ADDENDUM #3

C20004 – US 101/BLOSSOM HILL ROAD INTERCHANGE IMPROVEMENT

ISSUE DATE: APRIL 28, 2020

TYPICAL SECTION SOUND WALL No. 1
SW1. 508+03.50 TO 508+83.50
NO SCALE

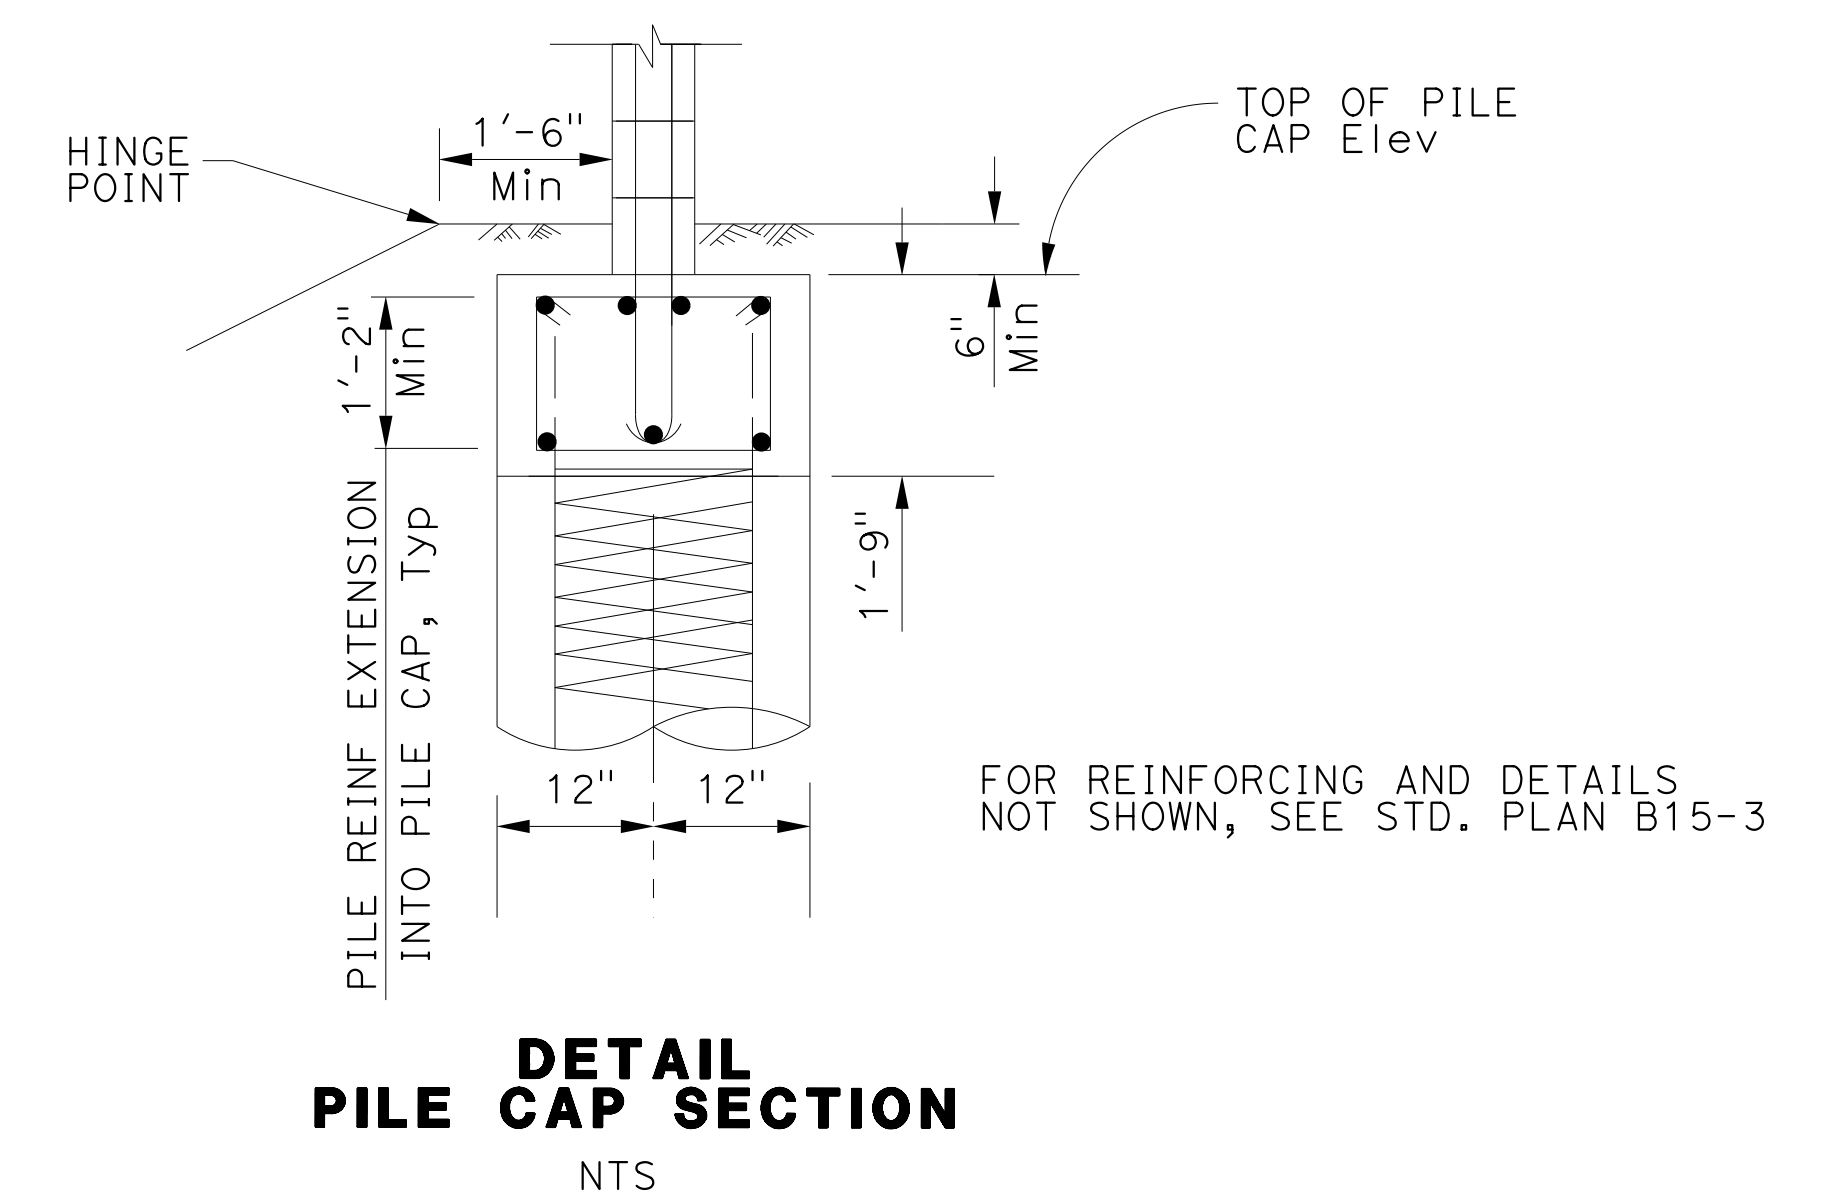
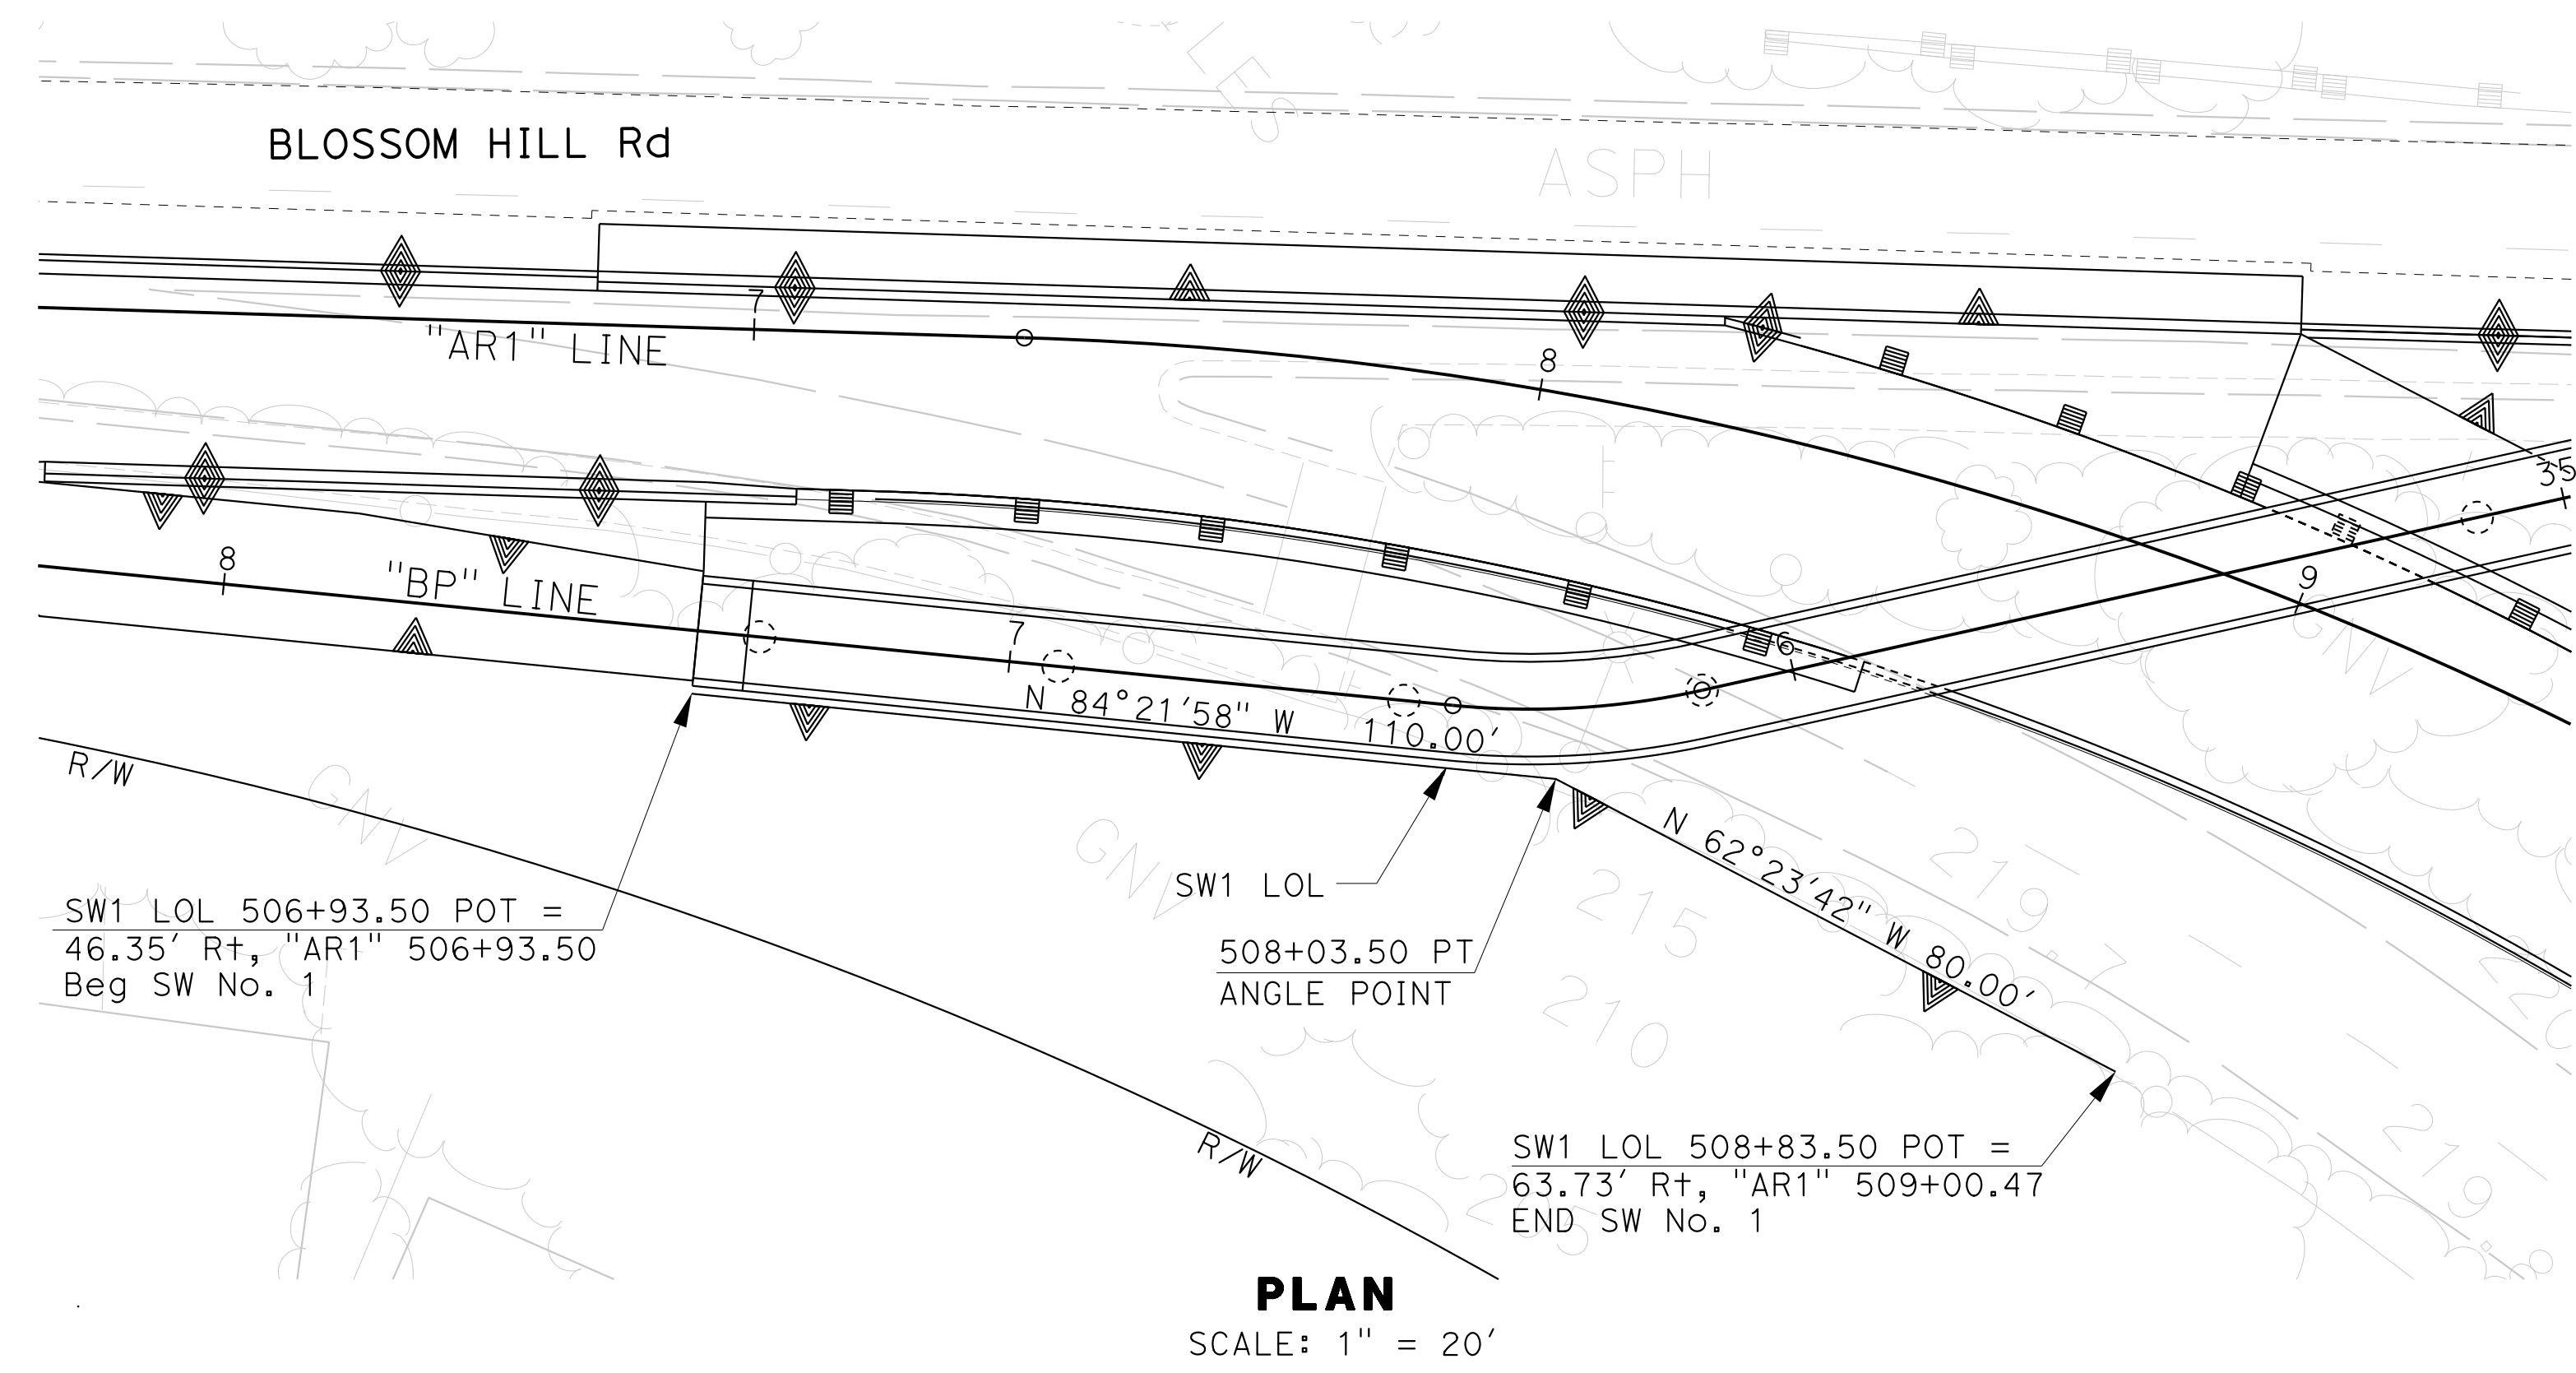
9. **REPLACE** drawing SW-1 with the attached revised drawing SW-1.
